CONSIDERATION OF AND/OR ANY APPROPRIATE ACTION ON PANORAMA STREET PRELIMINARY PLAT, SITUATED IN THE PHILLIP ANDERSON SURVEY, ABSTRACT NO. 10 CITY OF PARKER, COLLIN COUNTY, TEXAS. [MACHADO]

Re: Panorama Street
 Preliminary Plat and Engineering Plan Review

As you requested, we have reviewed the Preliminary Plat & Engineering Plans for the Panorama Street Addition prepared by LJA Engineering, Inc. These documents include a new street and is therefore considered a major subdivision under section 155.025 of subdivision ordinance.

PRELIMINARY **LJA PROJECT ID**
NT561-0133
THIS DOCUMENT IS RELEASED
FOR THE PURPOSE OF
REVIEW
UNDER THE AUTHORITY OF
VERONICA B. HADLEY, TEXAS P.E.
#143748 ON
06/27/2023
THIS DOCUMENT IS NOT TO BE
USED FOR THE PURPOSES OF
CONSTRUCTION.
SCALE
HORZ: 1" = 100'
VERT: N/A
SHEET
4
OF 35 SHEETS

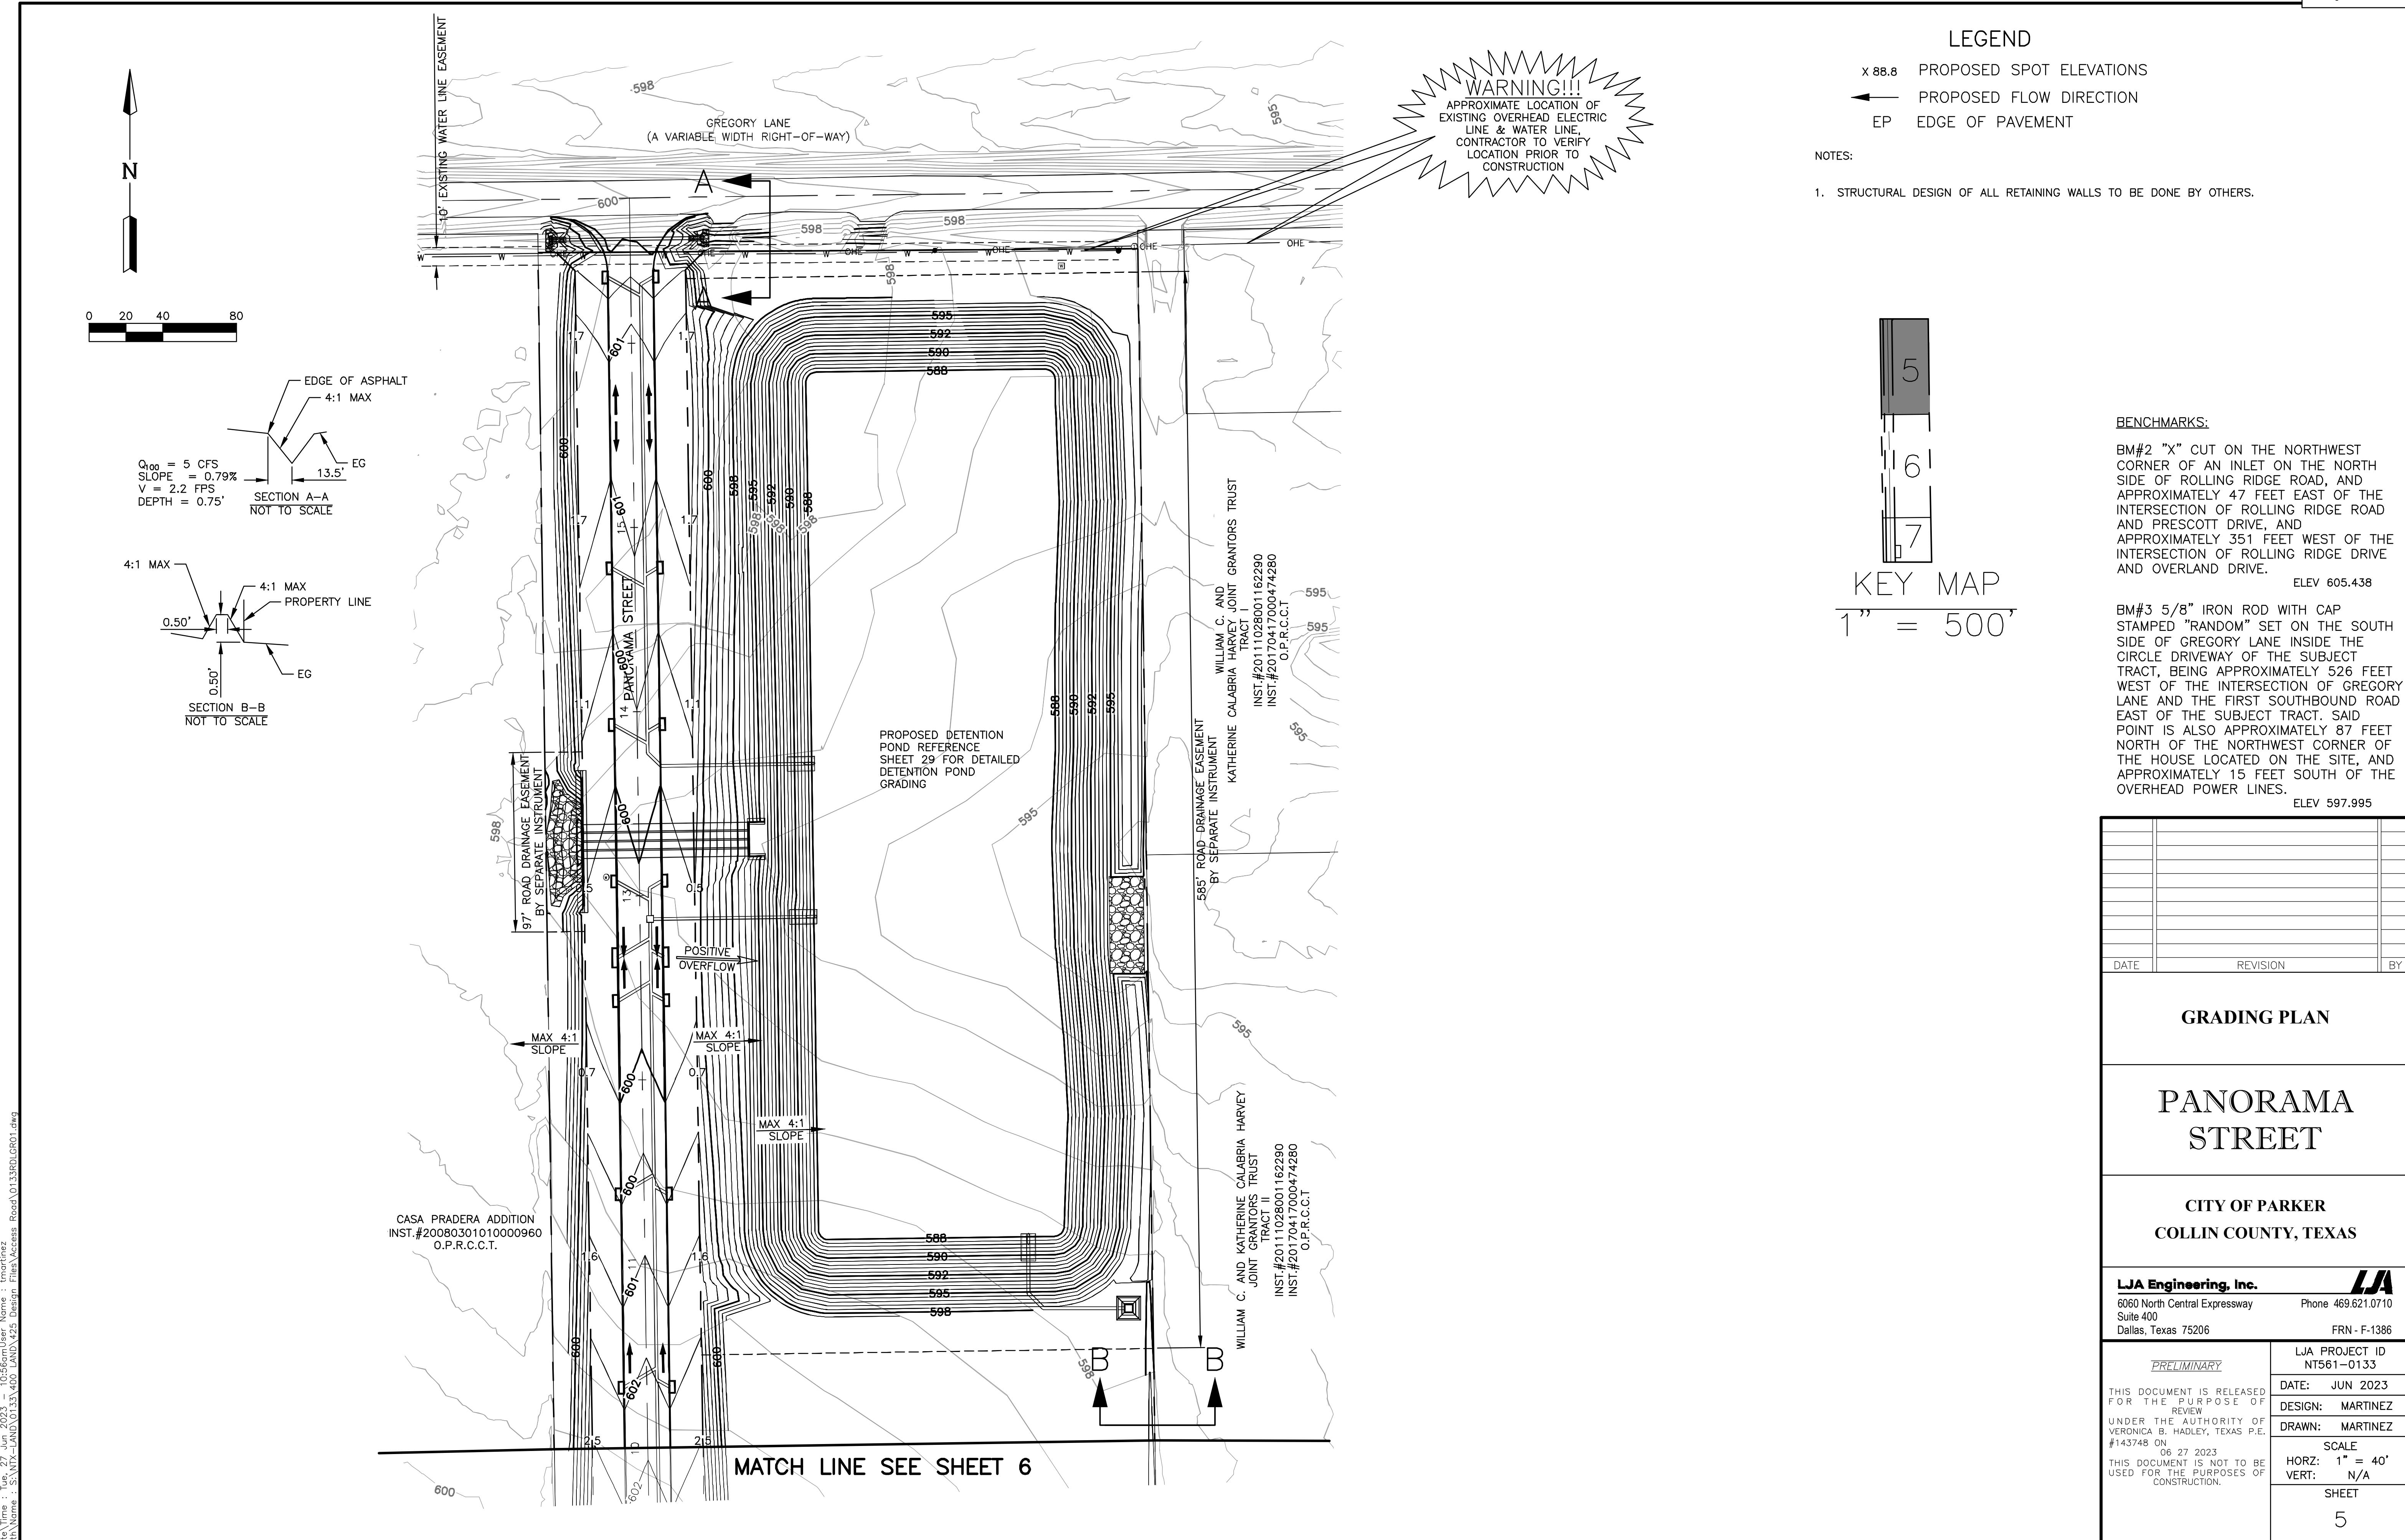
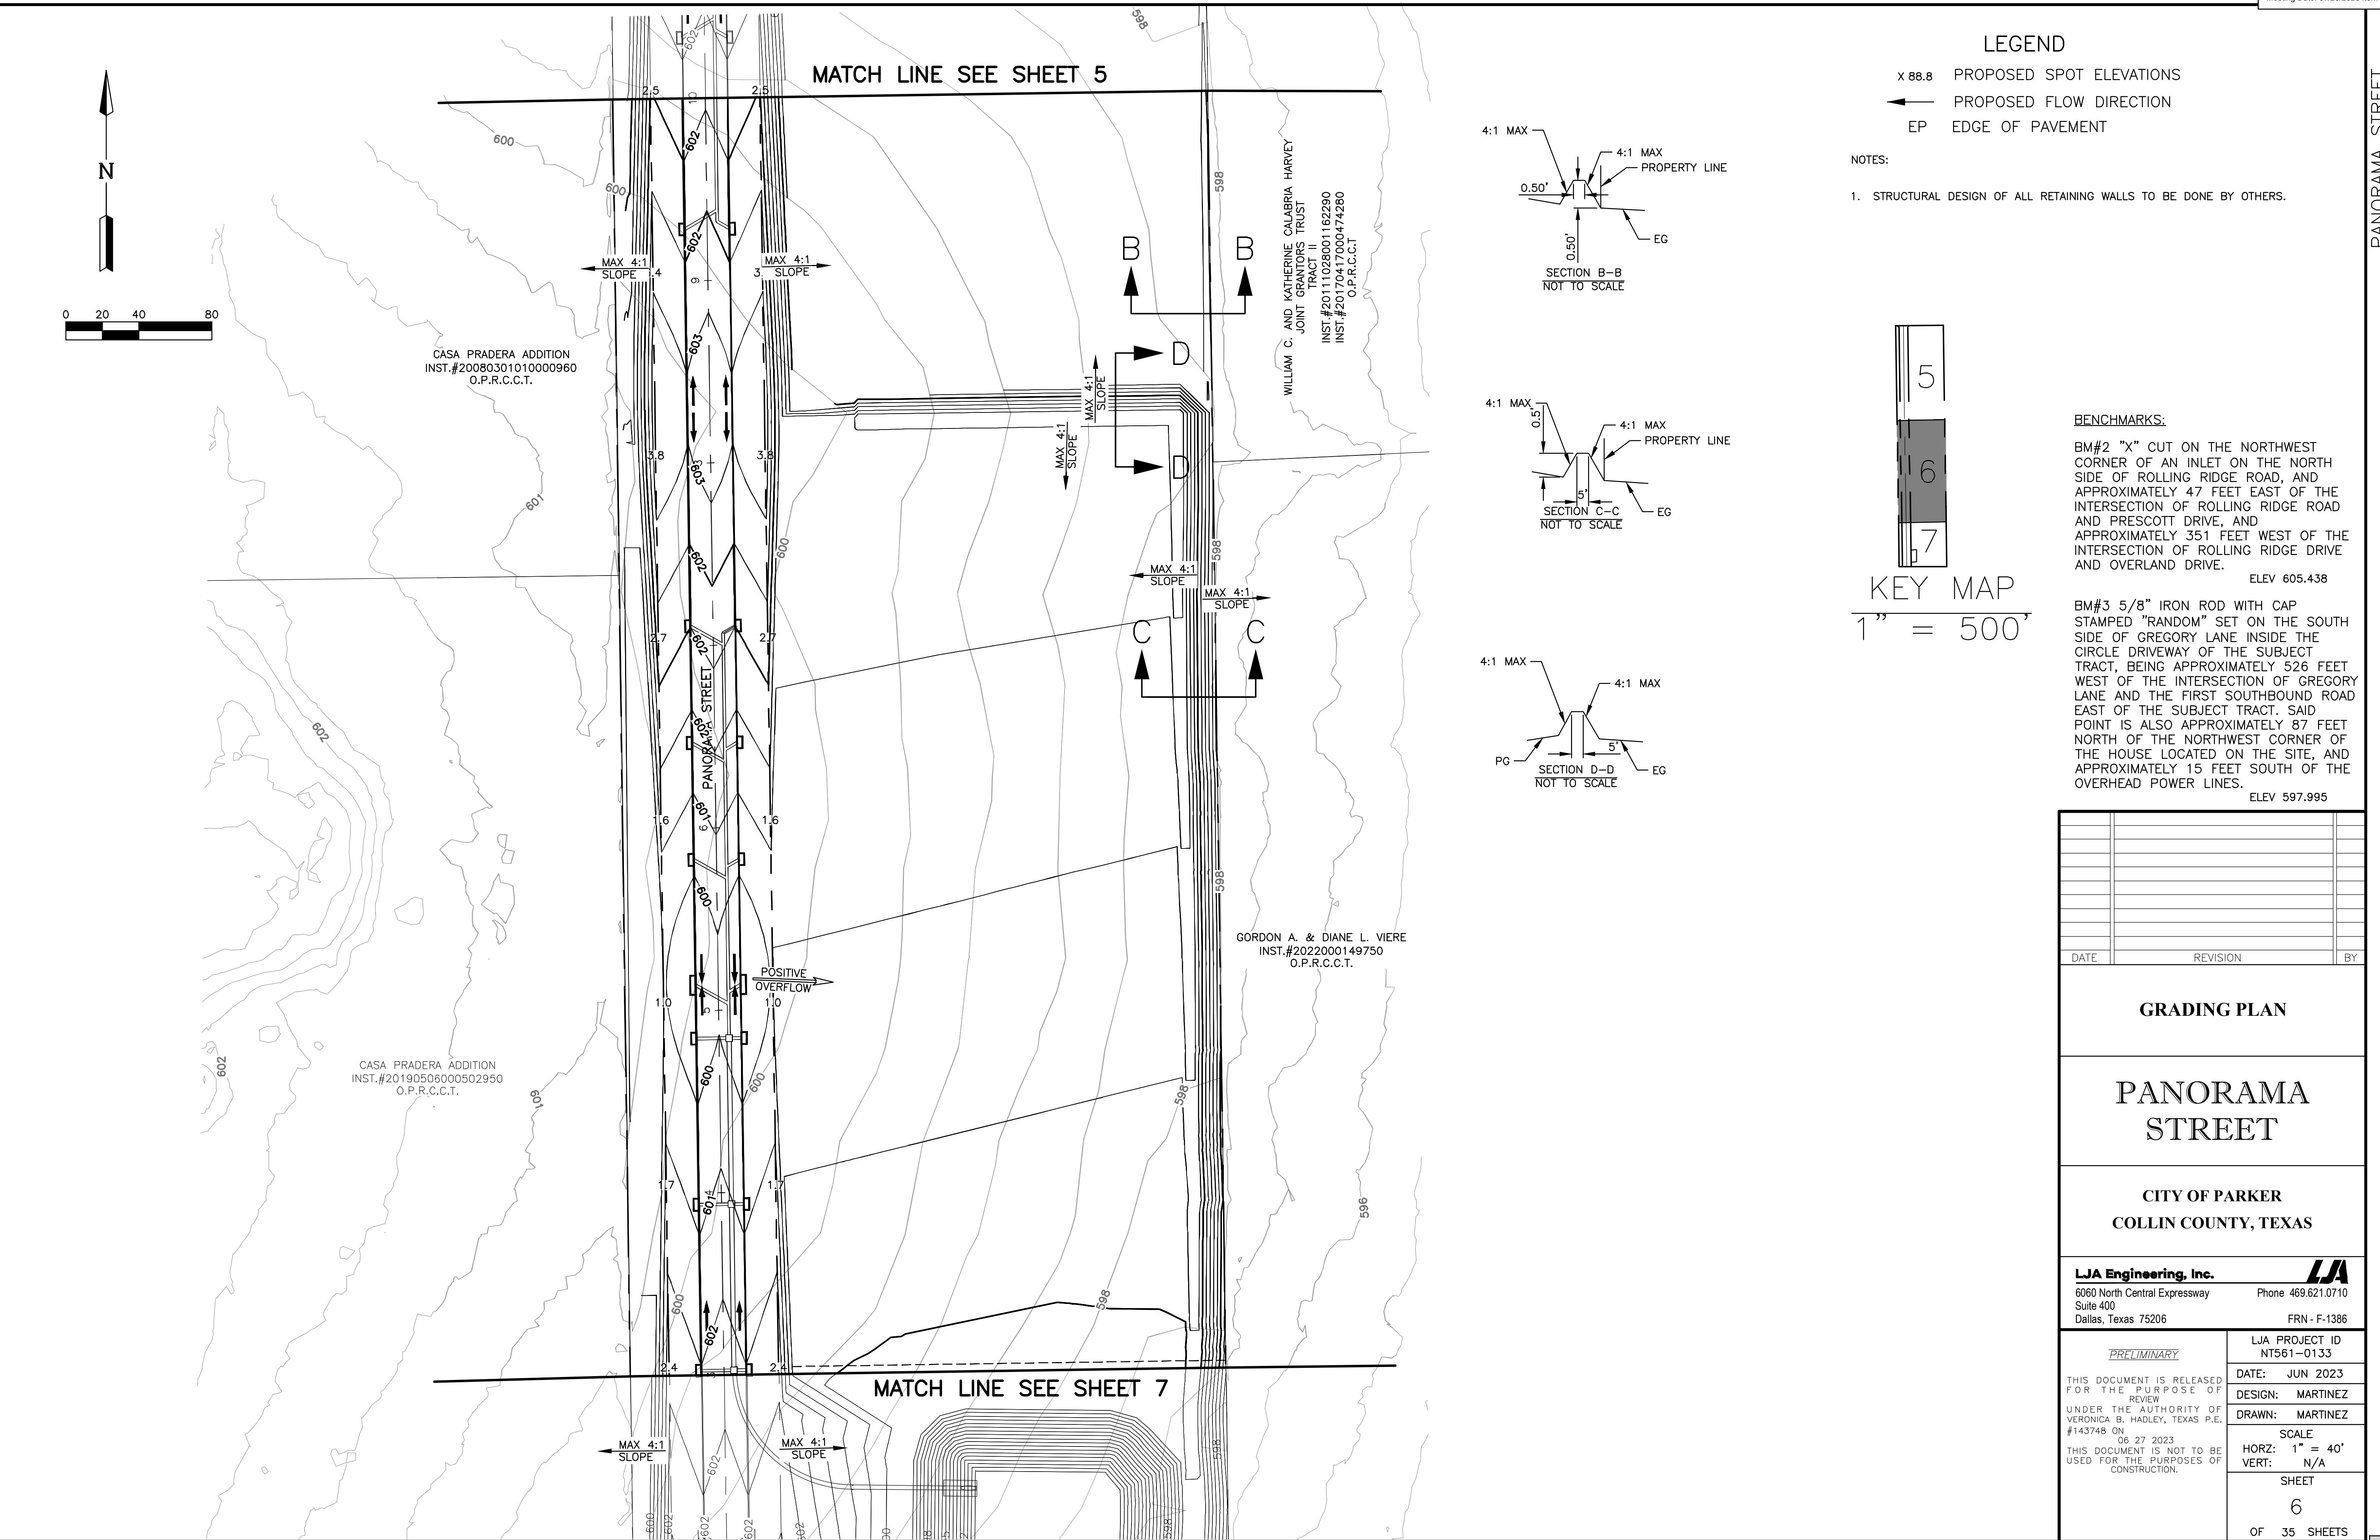
28. The Collin County Municipal Utility District No. 7 does not exist. Remove reference from plat.
29. Sheet 4 Provide details of new fences being proposed. Add note how to protect livestock when existing fences are removed.
